LAFORUCHE PARISH FIRE DISTRICT NO. 3

HURRICANE IDA DAMAGE RESTORATION
NORTH GALLIANO FIRE STATION NO. 15 RESTORATION
HURRICANE IDA RECOVERY NUMBER: HIR-NG15
FEMA DI-NUMBER: 1209205
GALLIANO, LAFOURCHE PARISH, LOUISIANA

ADDENDUM NO. 2

Date Issued: September 7, 2022

Plan Sheet 04 – Site Plan

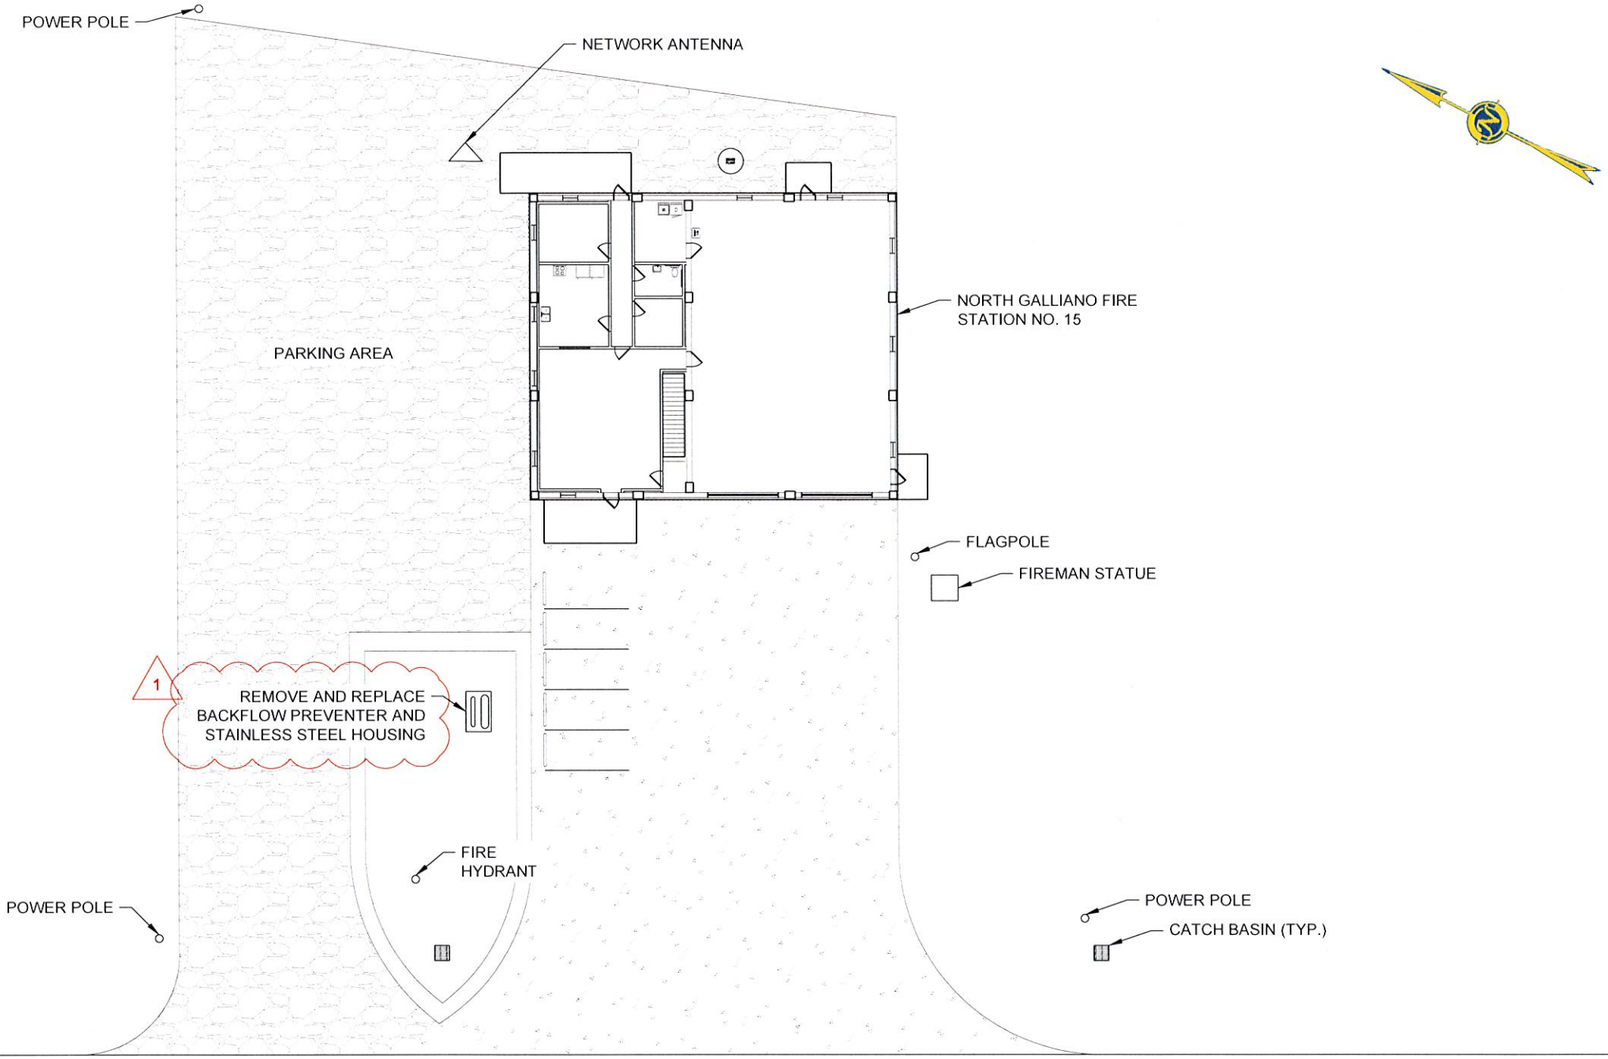
1 = ADDED REMOVE AND REPLACE BACKFLOW PREVENTER AND STAINLESS STEEL HOUSING

1. Plan Sheet 02 General Notes and Quantities
   a. Please replace with revised Plan Set 02 provided in this Addendum.
2. Plan Sheet 04 Site Plan
   a. Please replace with revised Plan Set 04 provided in this Addendum.
3. Plan Sheet 10 Elevation Views (Rear)
   a. Please replace with revised Plan Set 10 provided in this Addendum.

Plan Sheet 10 – Elevation Views (Rear)

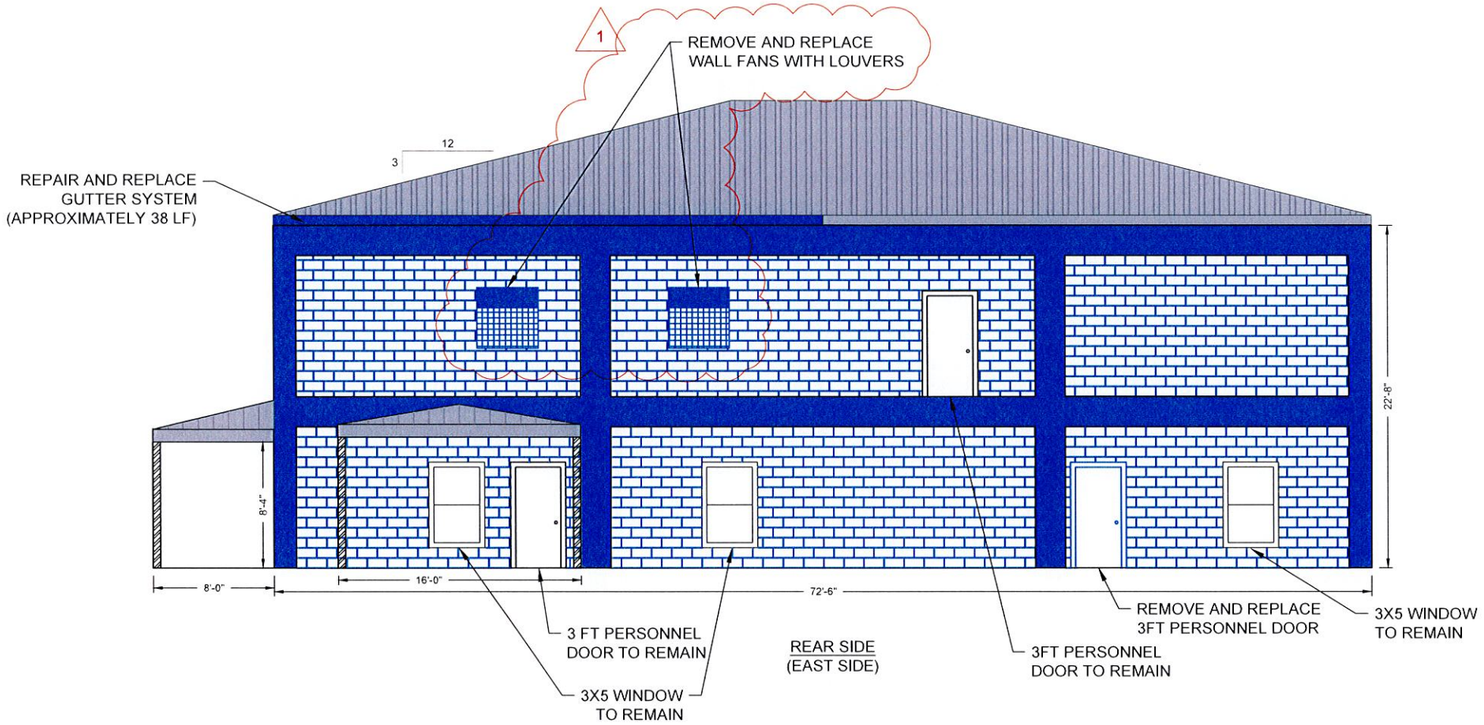
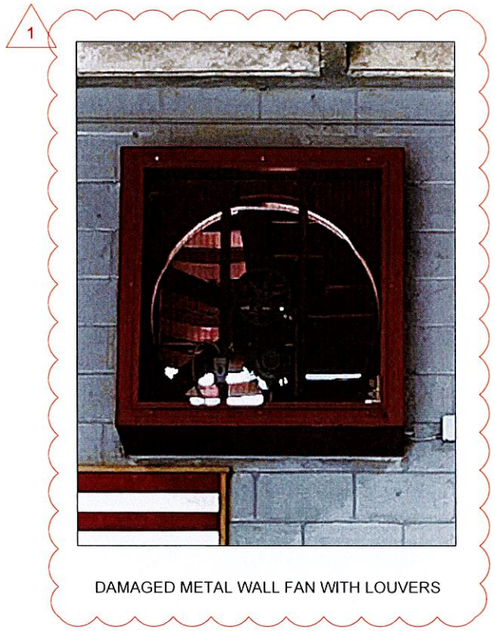
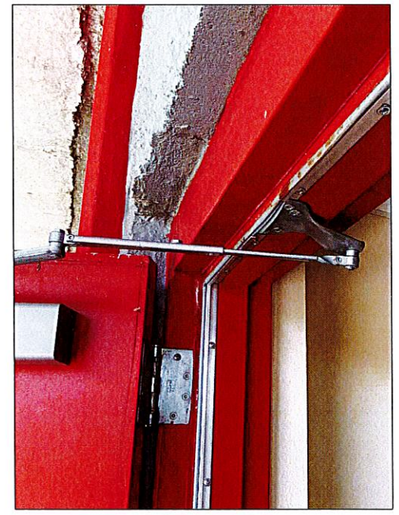
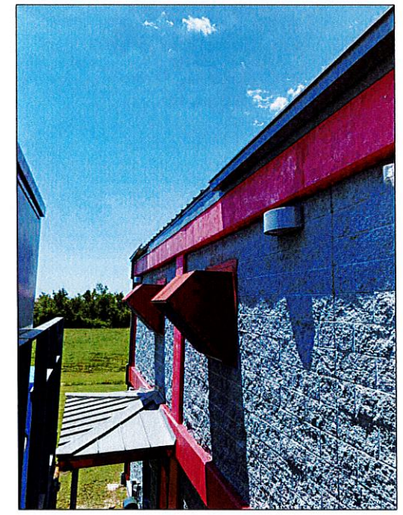
1 = ADDED REMOVE AND REPLACE WALL FANS WITH LOUVERS
